# UNITED STATES PATENT AND TRADEMARK OFFICE

| APPLICATION NO. | FILING DATE | FIRST NAMED INVENTOR | ATTORNEY DOCKET NO. | CONFIRMATION NO. |
|-----------------|-------------|----------------------|---------------------|------------------|
| 10/668,747      | 09/23/2003  | Jin Shenghao         | 15865.6a.1          | 1791             |

| <b>Office Action Summary</b> | <b>Application No.</b><br>10/668,747 | <b>Applicant(s)</b><br>SHENGHAO ET AL. |  |

Fig. 2A

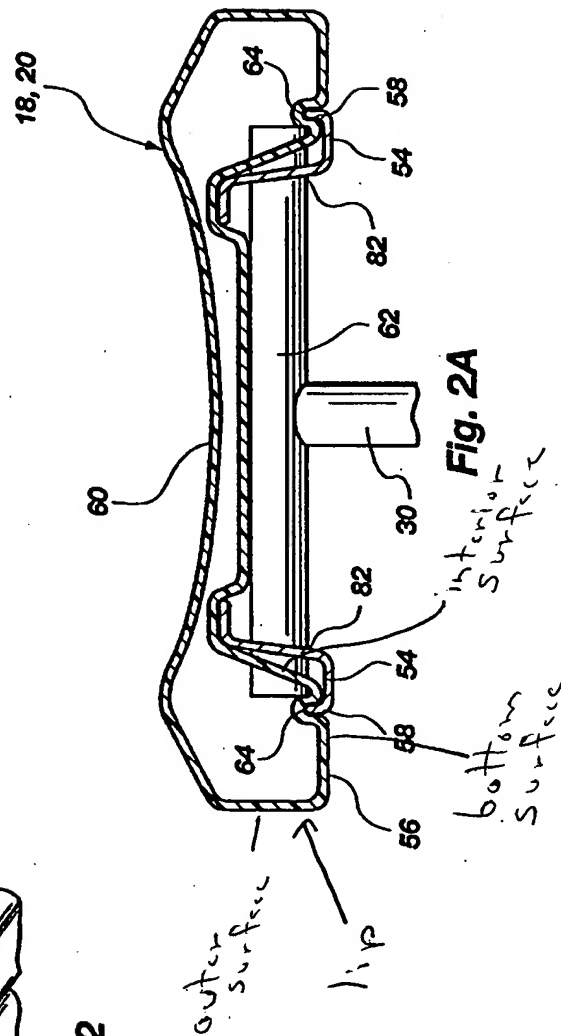
Claims 1, 3, 4, 8, 14, 16, 18 and 19 are rejected under 35 U.S.C. 102(b) as being anticipated by Nye et al (5,921,623). Nye teaches a table (Fig. 2A) comprising: a plastic blow molded table top (12) having a lip (see depending portion of 12 in Fig. 2A and Attachment A) with interior, outer and bottom

surfaces and a first connecting aperture (82) located in the interior surface; a first table leg (30); and a first cross pole (62) attached to a first end of the table leg and disposed in the first connecting aperture. The lip also includes a groove/recess (64). Since Nye teaches all of the structural limitations found in the method claims; the method steps would inherently be provided for.
